PSL optical layout changes for eLigo

Rick Savage and Anamaria Effler
LHO

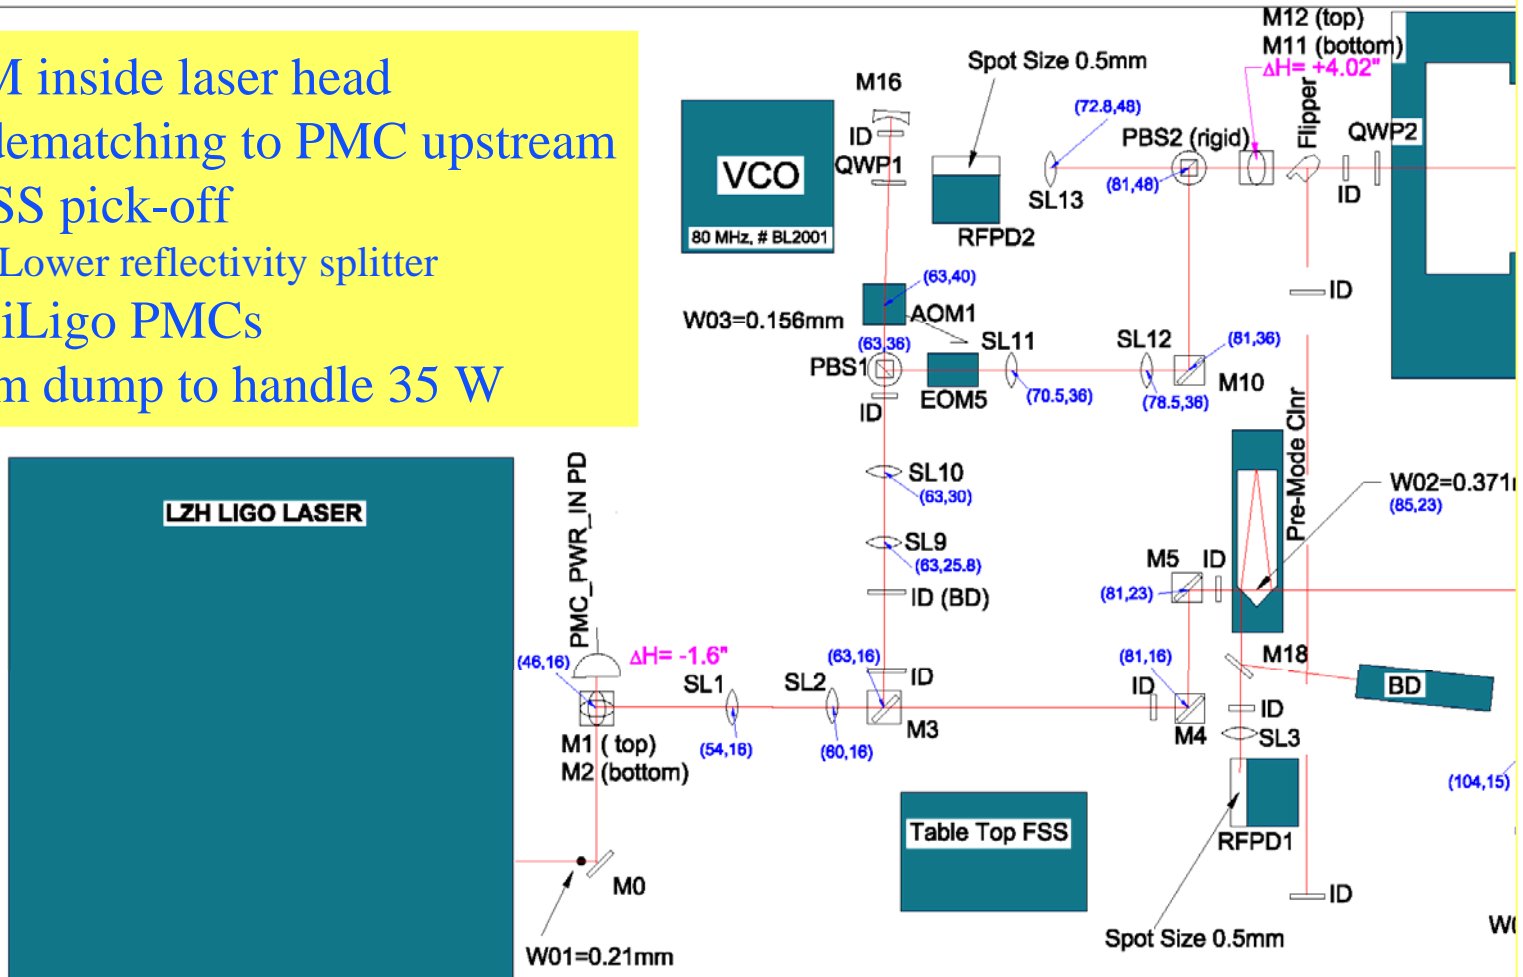
- Main path optics superpolished with custom AR coating

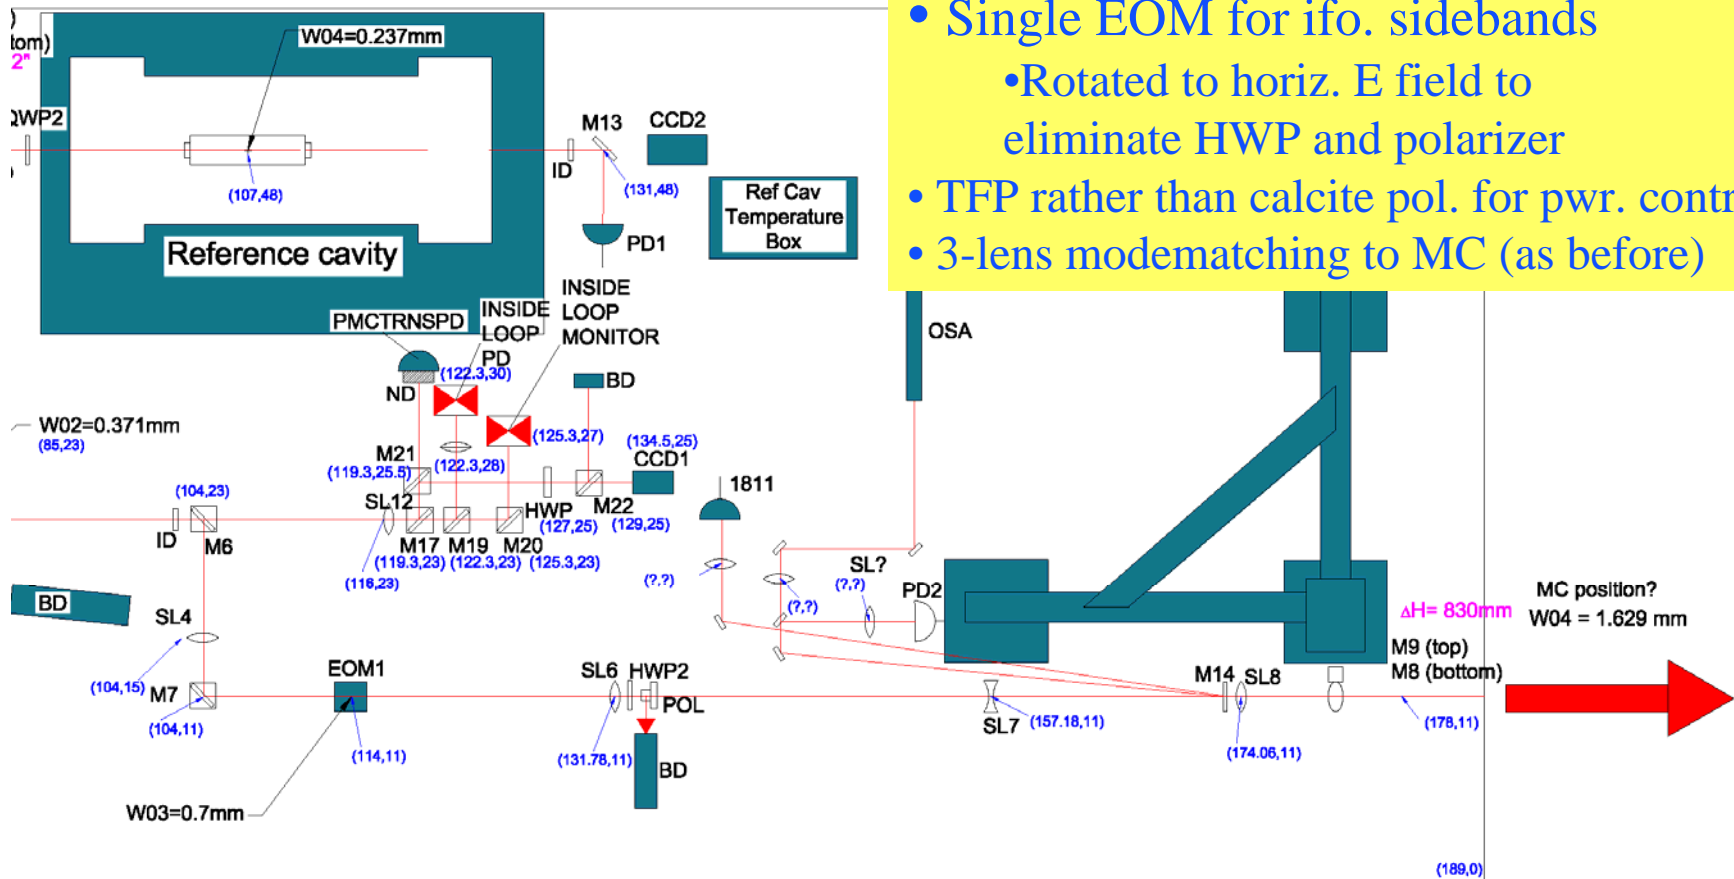
- EOM inside laser head
- Modematching to PMC upstream of FSS pick-off
 - Lower reflectivity splitter
- Use iLigo PMCs
- Beam dump to handle 35 W

- Single EOM for ifo. sidebands
 - Rotated to horiz. E field to eliminate HWP and polarizer
- TFP rather than calcite pol. for pwr. control
- 3-lens modematching to MC (as before)
